Attachment 4 - Amendment 32 - Representations

Re DA 0517/2016 SF 6533 Lindsay Street Site Specific S43A Amendment

**Re: DA 0517/2016.
1-11,13,15,17,19-21 & 23-25 Lindsay Street Inveresk,
Proposed Car Park. SF6533 - Amendment 32 Site specific amendment to
include Vehicle Parking as a discretionary use in the Open Space Zone
for 9 subject titles on the Levee Bank in Lindsay Street.**

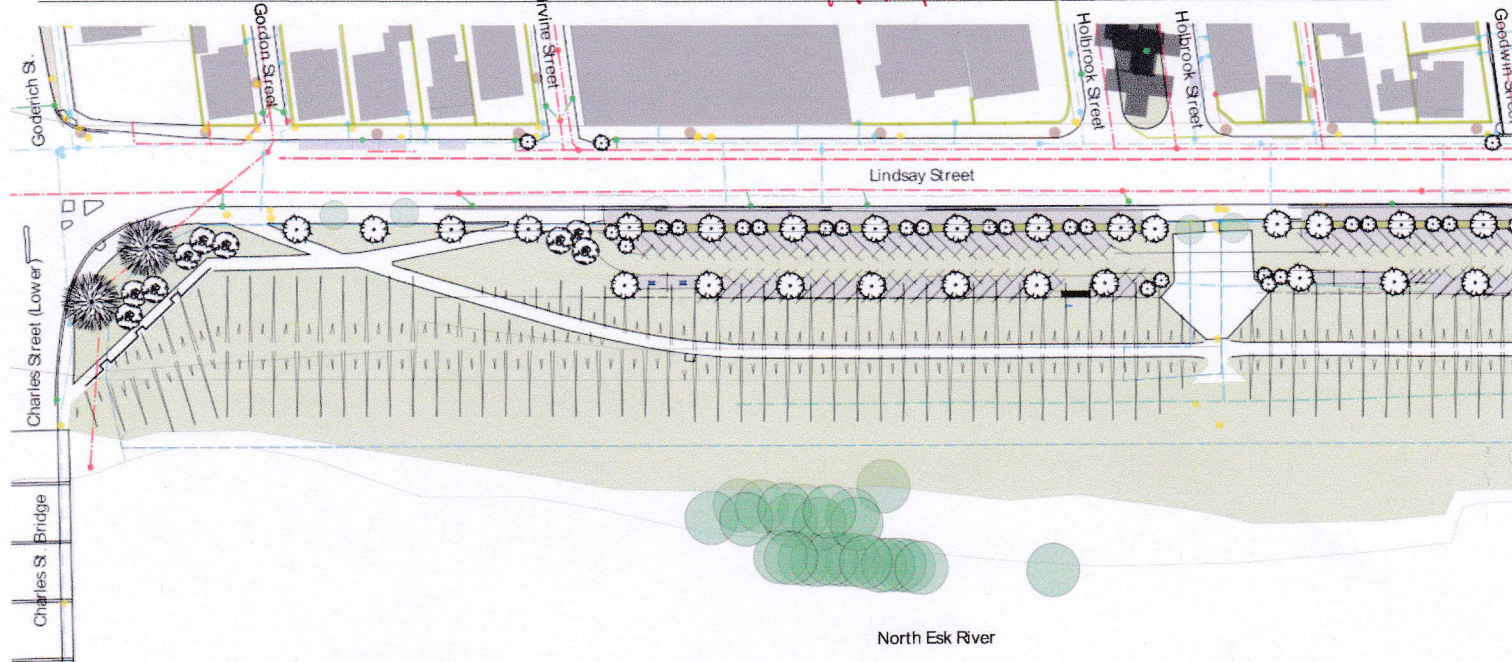
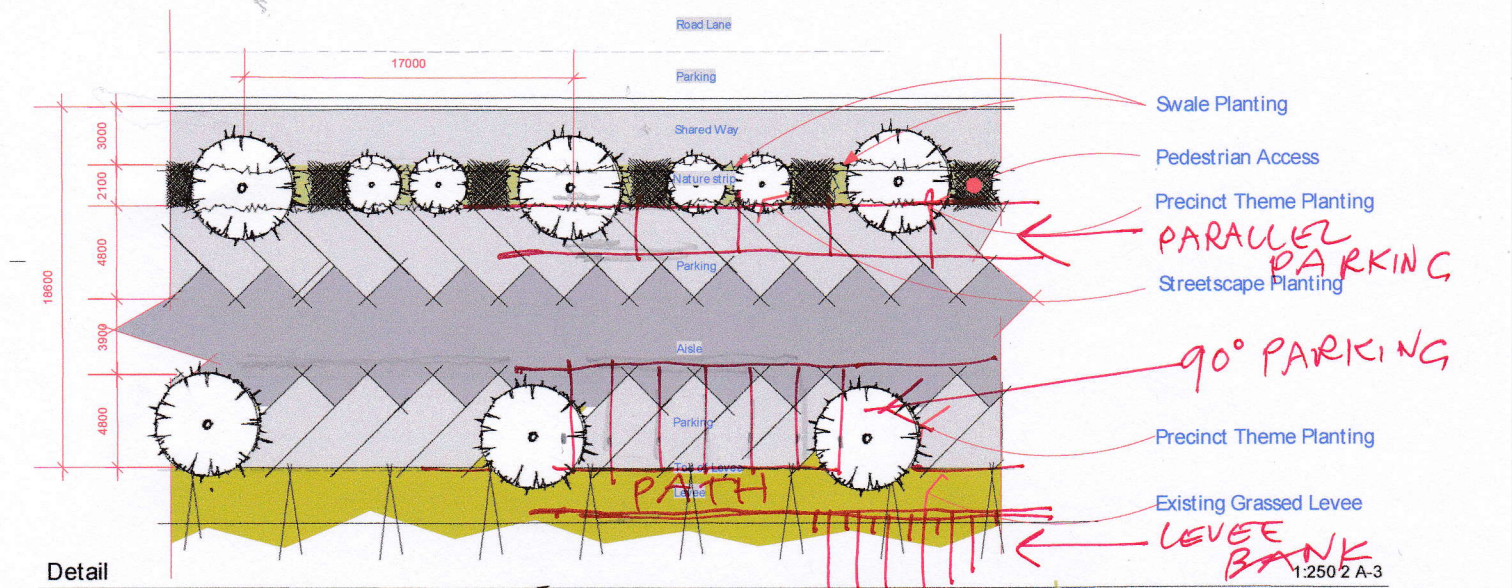
The Lindsay St landscape buffer should be increased from 2100 to 2500. Decrease the internal traffic aisle from 3900 to 3500 to compensate. Provide an extra 4 landscape modules, [delete 4 car spaces], along Lindsay St.

It is good that the full length of the Lindsay St boundary is proposed to be planted as an avenue. [If I may], the effect might be enhanced if the large tree plantings at 17000 spacing were replaced with smaller trees at say 10000.
